1. Type of Well	_					8 Well Name and No	
✓ Oil Well	Gas V					8. Well Name and No. STRE	EETCAR 15 FED 103H
2. Name of Operator EOG						9. API Well No. 30-025-474	
3a. Address 1111 BAGBY	SKY LOE	BBY 2, HOUSTON, TX 77	3b. Phone N (713) 651 -3		ode)	10. Field and Pool or Explor /DRAPER MILL; BONE	-
4 Location of Well (Footage	e Sec. T. I	R.,M., or Survey Description)	(713) 031-	7000		11. Country or Parish, State	
SEC 15/T25S/R33E/NM		c,m., or burvey Description)				LEA/NM

EOG respectfully rec the following change		amendment to our approve	d APD for	this well to reflect	rt -		
Streetcar 15 Fed 103	3H API #:	30-025-47498					
0		33-E, Sec 15, 671' FSL, 235 00' FSL, 1324' FWL, Lea Co		ea Co., NM,			
0		33-E, Sec 15, 100' FNL, 232 00' FNL, 1540' FWL, Lea Co		ea Co., NM,			
Update casing and c Continued on page 3	•	ogram to current design. al information

Revised Permit Information 10/04/2023:

Well Name: Streetcar 15 Fed 103H

Streetcar 15 Fed 103H

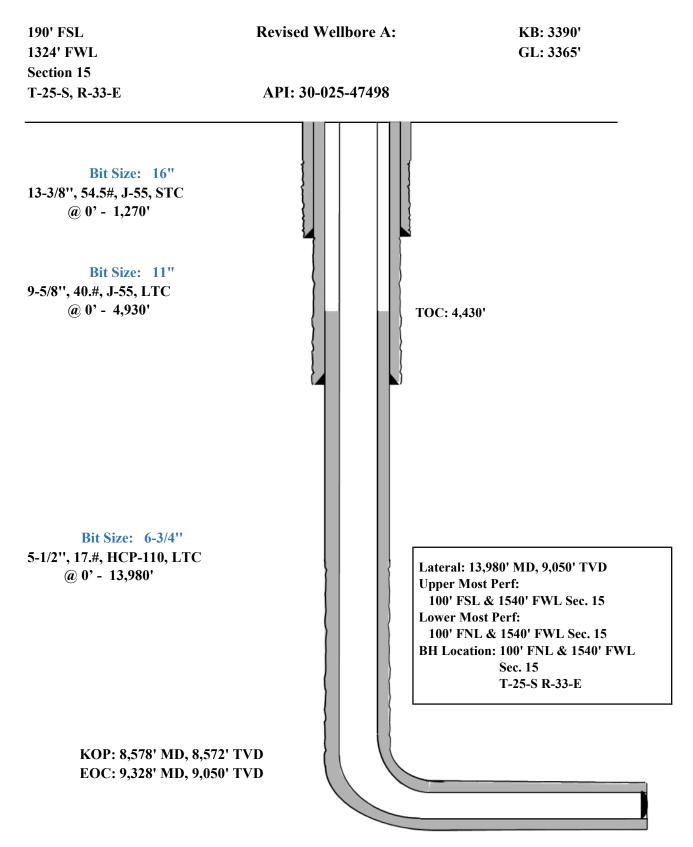
Casing Program B:

Hole	Interv	al MD	Interva	ıl TVD	Csg			
Size	From (ft)	To (ft)	From (ft)	To (ft)	OD	Weight	Grade	Conn
13-1/2"	0	1,270	0	1,270	10-3/4"	40.5#	J-55	STC
9-7/8"	0	4,002	0	4,000	8-5/8"	32#	J-55	BTC-SC
9-7/8"	4,002	4,932	4,000	4,930	8-5/8"	32#	P110-EC	BTC-SC
6-3/4"	0	13,980	0	9,050	5-1/2"	17#	HCP-110	LTC

Variance is requested to waive the centralizer requirements for the 8-5/8" casing in the 9-7/8" hole size. An expansion additive will be utilized, in the cement slurry, for the entire length of the 9-7/8" hole interval to maximize cement bond and zonal isolation.

Variance is also requested to waive any centralizer requirements for the 5-1/2" casing in the 6-3/4" hole size. An expansion additive will be utilized, in the cement slurry, for the entire length of the 6-3/4" hole interval to maximize cement bond and zonal isolation.
